Agenda – City Centre Community Committee – November 16, 2026

Item No. 2 Variance – 491-507 Sherbrook Street
(Daniel McIntyre Ward Ward)
File DAV 197790/2026D [c/r DASZ 9/2026]

ADMINISTRATIVE REPORT

Title: DAV 26-197790\D – 491-507 Sherbrook St

P100A

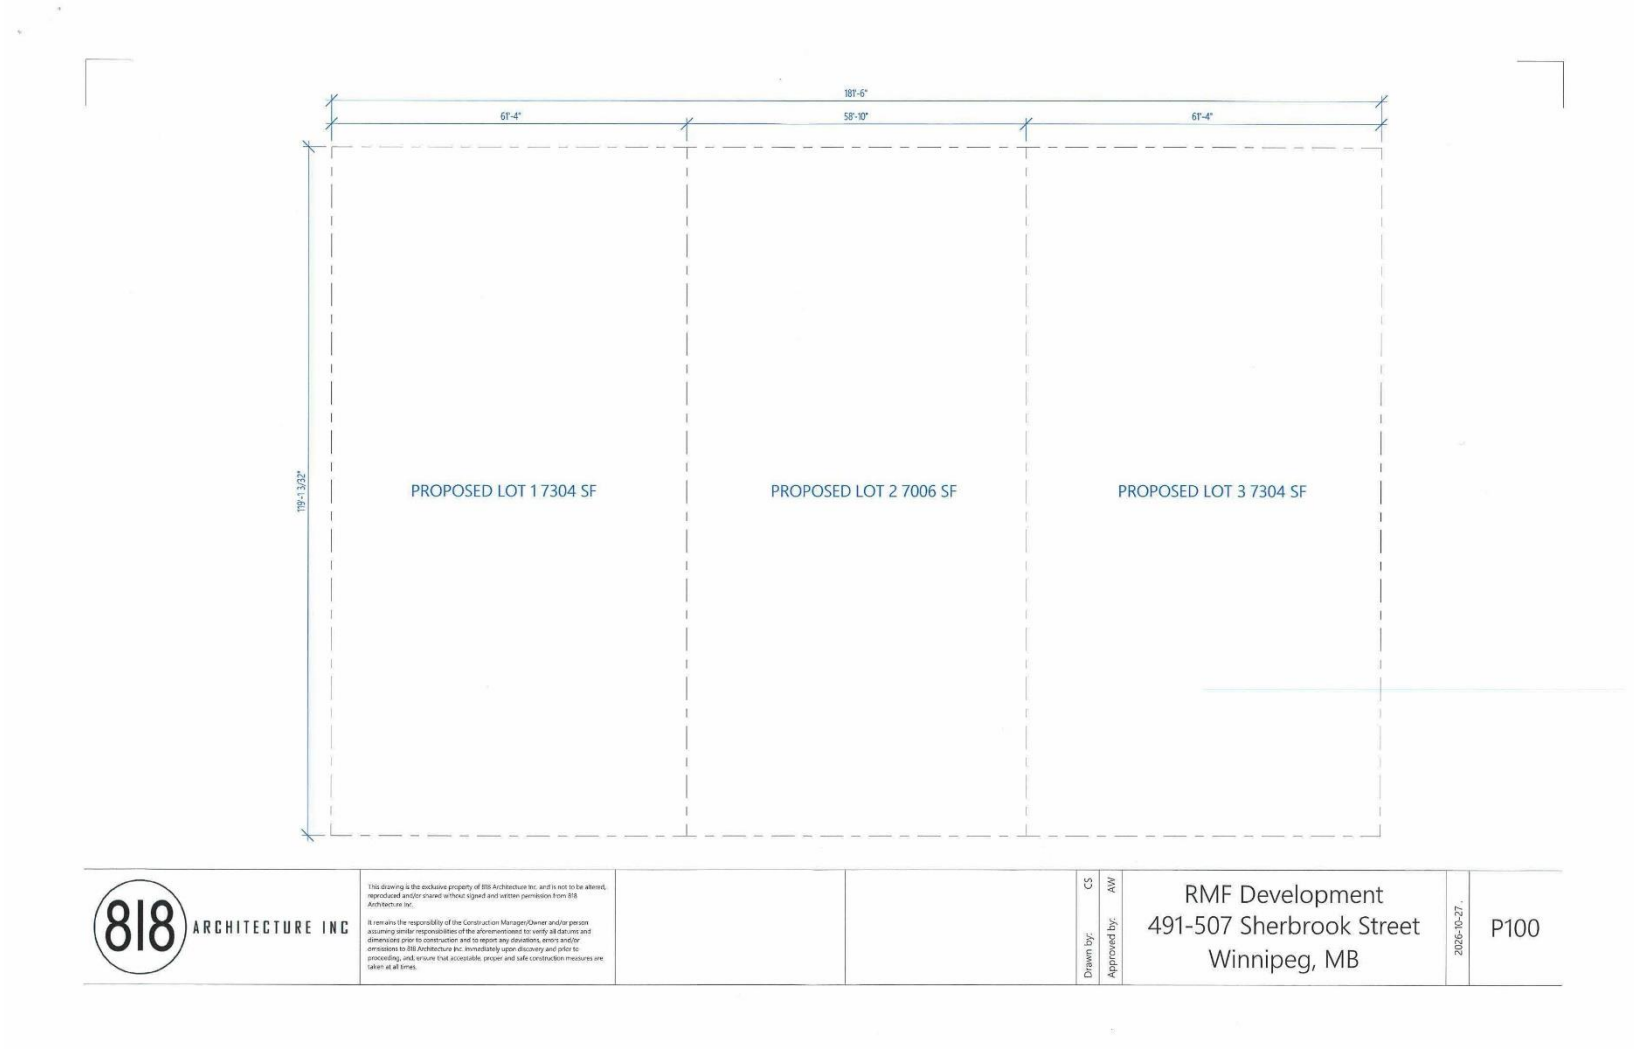
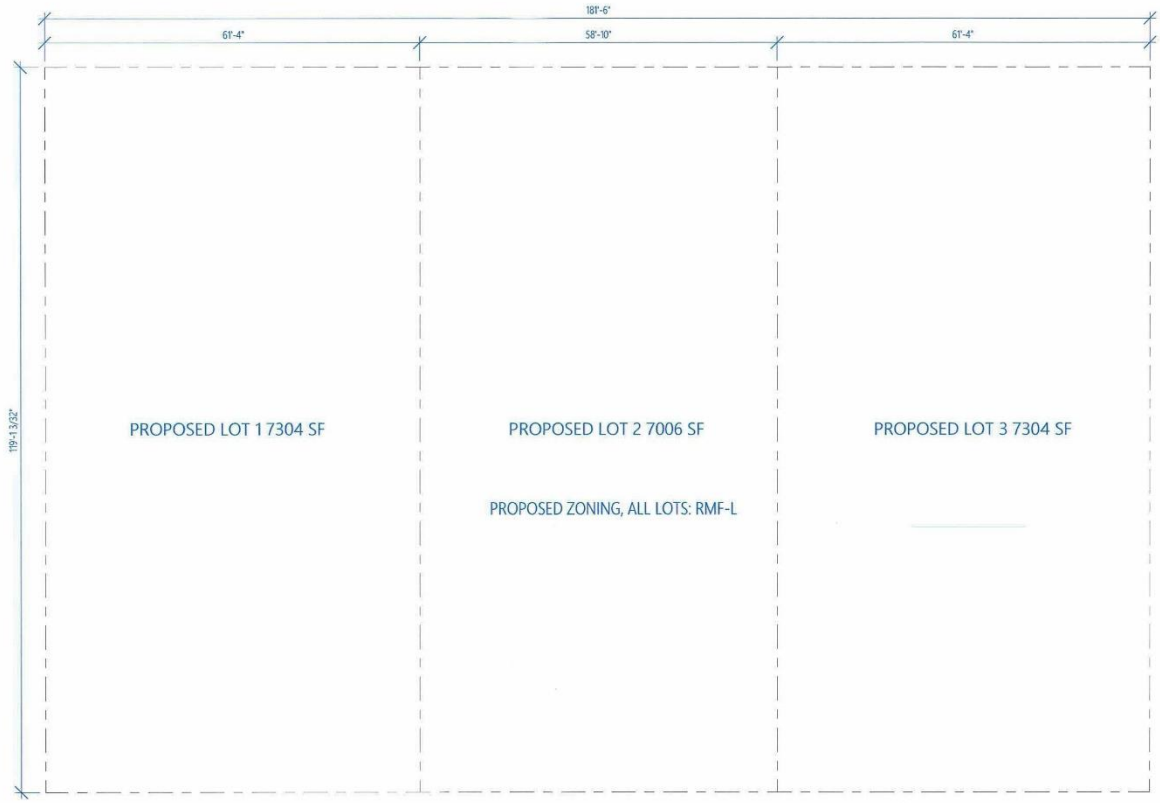
- At this time, the applicant has submitted one site plan showing the three buildings, and one set of elevations showing one building. Their intent is to submit additional sets of elevations that show a distinct building on each lot when they seek Plan Approval in future. The currently submitted plans and elevations show:

- A three storey (38’ – 8 13/32”) building oriented towards Sherbrook Street.
    - An 8’ – 7 3/32” front yard to the Sherbrook Street property line.

- A 9’ 2” side yard to the properties abutting the subject site, and a 6’ 8” side yard between the proposed new buildings.
    - A 26’ 6” rear yard setback to the lane.

- A varied roofline, covered entryway, and balcony oriented towards Sherbrook Street.
- The site plan also shows:
    - 18 parking stalls, including three accessible stalls.

- The Public Service requested that the applicant move their building further back from the front property line in order to preserve the existing boulevard trees. The Public Service agreed to support parking stall lengths of 21’ instead of 23’ as a means to accommodate a greater front yard.
- The applicant agreed and moved the proposed building back by 2’.

The proposed front yard setbacks are 8'-7 3/32", bringing the future buildings close to the front property line along Sherbrook Street and enhancing the pedestrian orientation. This is a common feature on this block, where buildings exist close to or at the front property line, including 485, 488, and 508 Sherbrook Street. These features – paired with a modest building height and ample window coverage, define a clear edge, supporting the pedestrian environment.

- The street edge landscaping requirement for these properties is a total of two trees and nine shrubs, while the applicant has proposed one tree and 11 shrubs. For these reasons, Variances are needed.

- Parking within 20' of a rear lot line is required to be buffered if it is adjacent to residential uses. In this case, the application shows parking perpendicular to the lane with no buffering between the stalls and the lane.

i) a front yard of ~~6.5 feet (1.98 metres)~~ 8.5 feet (2.59 metres) instead of 25 feet (7.62 metres);

~~iv) insufficient street edge landscaping;~~

- The applicant intends to provide all required street edge landscaping, making this Variance no longer necessary.
